# THE ENSTROM HELICOPTER CORPORATION

## SERVICE INFORMATION LETTER

SERVICE INFORMATION LETTER NO. T-034

1. SUBJECT: Sliding Window Installation
2. MODEL: TH-28, 480, and 480B
3. EFFECTIVITY: All
4. BACKGROUND:

**Figure 1**

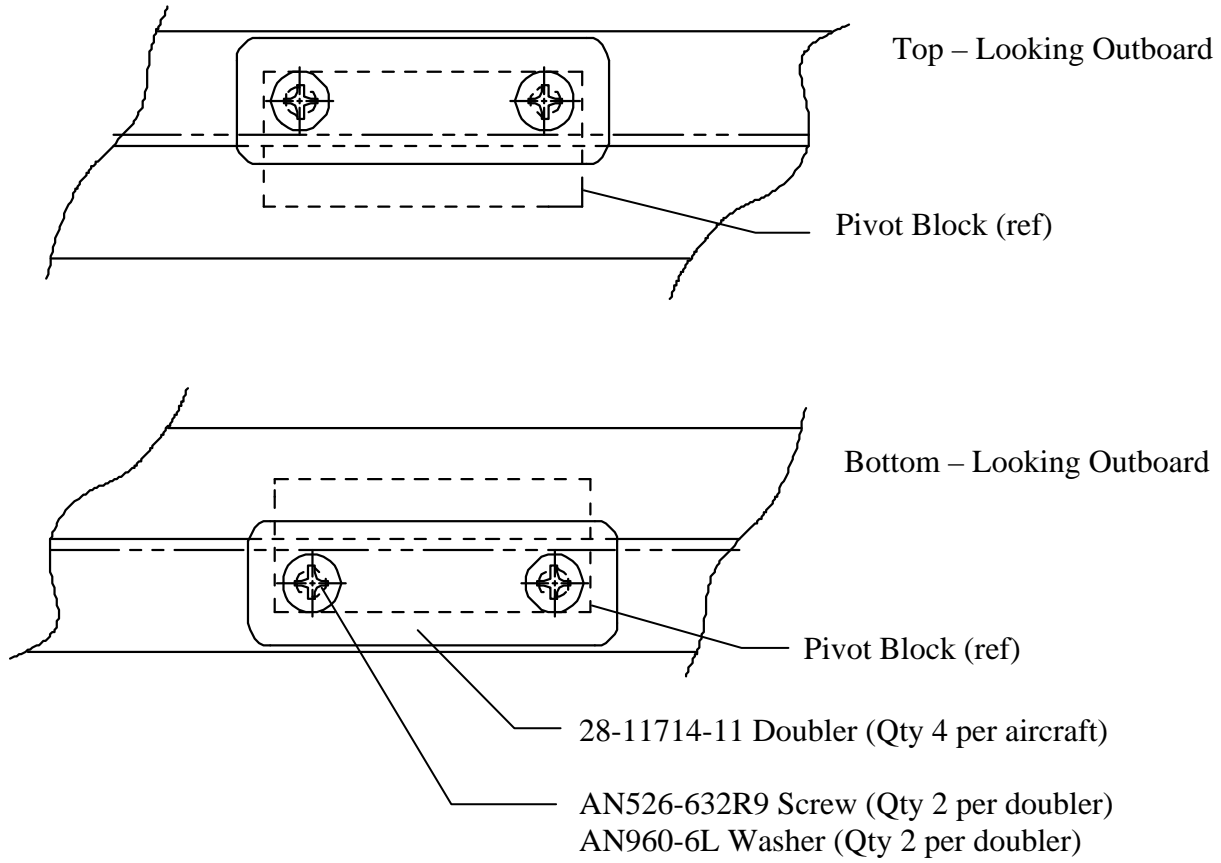
Enstrom has received reports regarding cracks generated about the sliding window frame at the location of either the upper or lower vent window pivot blocks. The cause for cracks has not been identified but may be attributed to the quality of the workmanship during production assembly, such as overtightening hardware and/or improper deburring of the attachment holes in the acrylic window structure. For an improvement, Enstrom has designed a doubler installation to reinforce the door window in the area of the pivot blocks.

- A. Slide the window aft to avoid damaging the window during the doubler installation.
- B. Remove the two screws that are installed from the inside of the window that screw into the wing window hinge blocks.
- C. Inspect the screw holes for cracks. If cracks are detected, contact Customer Service.
- D. Position the doubler by aligning the two attachment holes of the doubler with the two holes used to attach the pivot block. See Figure 1.
- E. Install the attachment hardware listed in paragraph 5.2 (8 in-lb max. torque).

- F. Repeat Steps A through E for the three remaining doublers.

Description	Part Number	Quantity
Doubler	28-11714-11	4
Screw	AN526-632R9	8
Washer	AN960-6L	8
